Hingley 18H-N167 doc no 401513954

COGCC is reviewing the Form 2A for the Creston Hingley 18H-N167 location (doc no 401513954). In order to complete our review, please address the following:

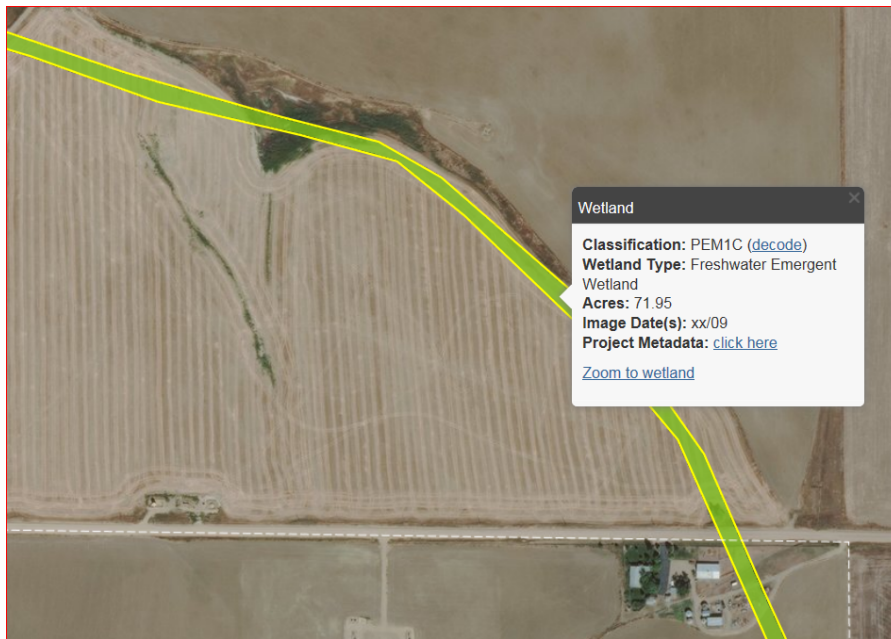
1. I have removed the CPW consult for SWH per our phone conversation on 5/9/18.
2. The MLVTs are located on a wetlands. Has Crestone discussed the disturbed area or reclamation with the Army Corp of Engineers? What are Crestone's plans for protection of the wetlands? I have a clip from the wetlands mapper below.
3. For the siting rationale, COGCC needs more information regarding planned development, economic considerations, discussions with the neighboring building unit owner in the buffer zone, etc.
4. Please provide an odor and dust BMP for drilling and completions operations.
5. Please provide a BMP for light mitigation
6. Please provide a BMP for 604.c.(2).T - Well site cleared, U - Identification of plugged and abandoned wells, and V - Development from existing well pads
7. For the noise mitigation, please provide site specific information, including placement of sound walls.

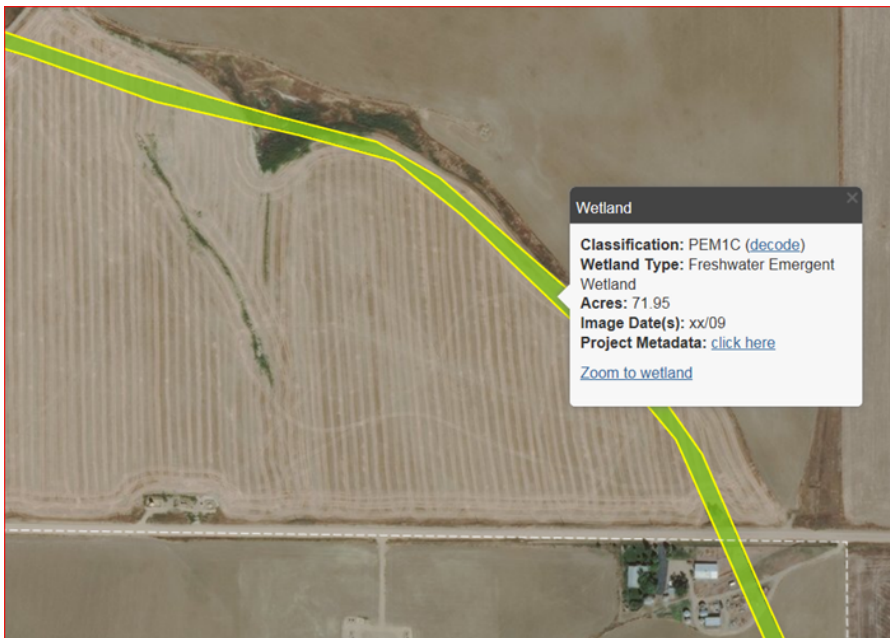
6. Please provide a BMP for 604.c.(2).T - Well site cleared, U - Identificaton of plugged and abandoned wells, and V - Development from existing well pads

11 wells will be drilled from this pad. The facilities location was placed 551' away from the nearest building unit while balancing surface owner restrictions related to future development as well as topographical constraints.

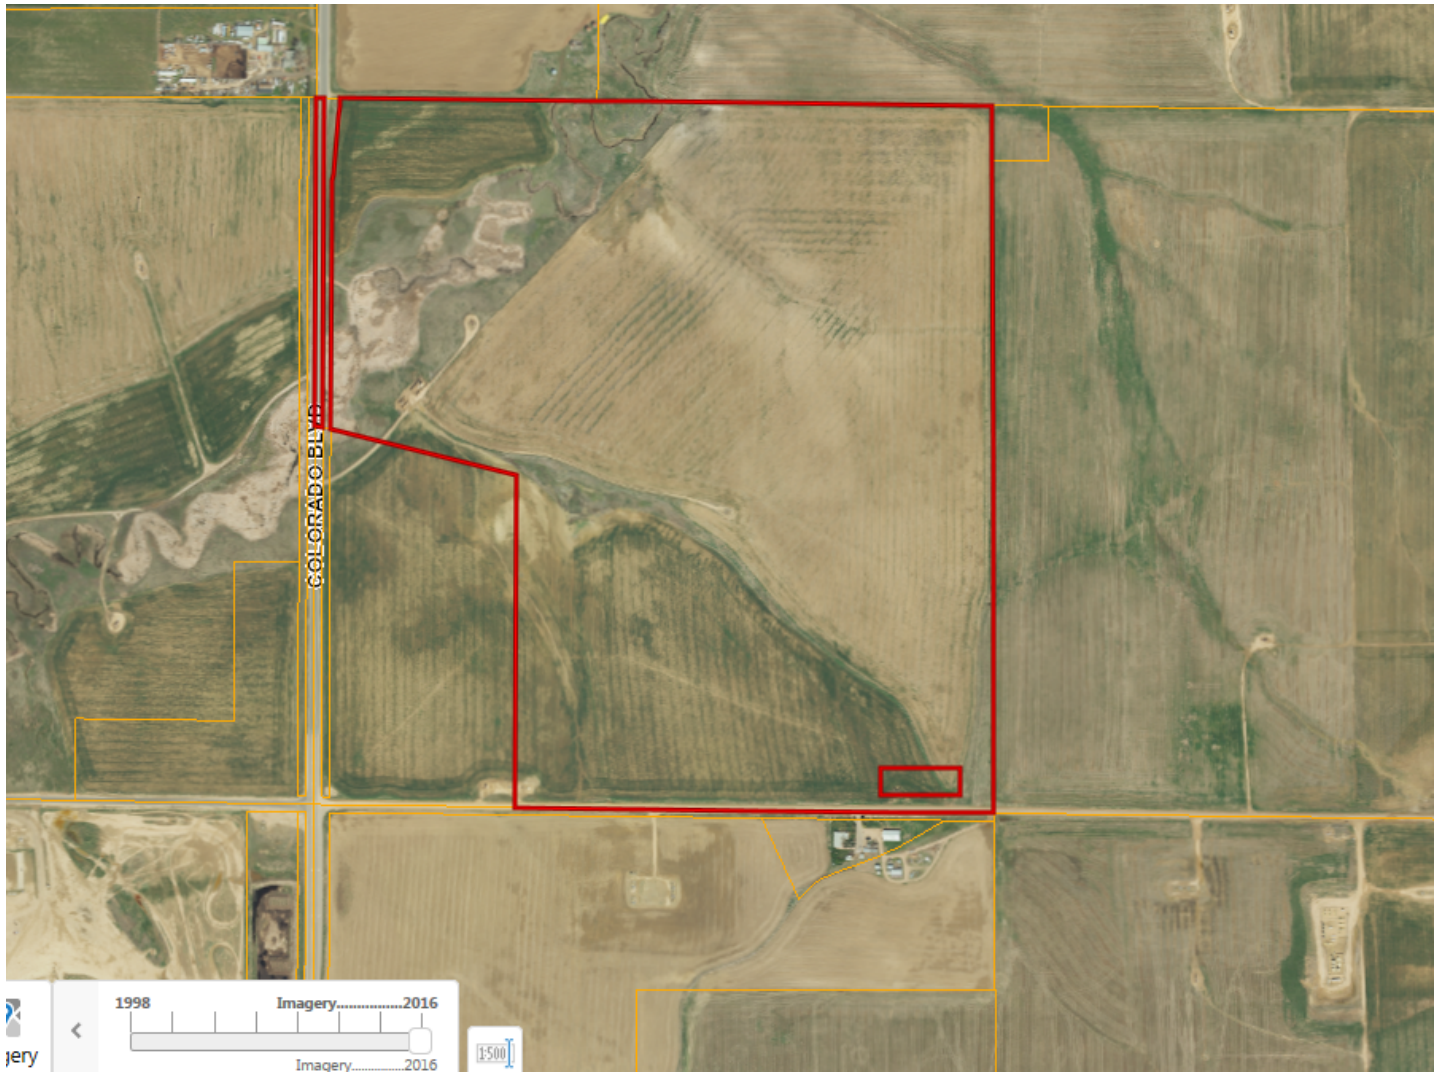
Meghan,
 What is the rectangle down by the building units?

That actually is a different parcel. Sometimes we have outlines on our drawings which show the various parcels. See screen shot from Weld County Assessor site.

Am I understanding correctly that you want revised drawings with the parcel box removed?
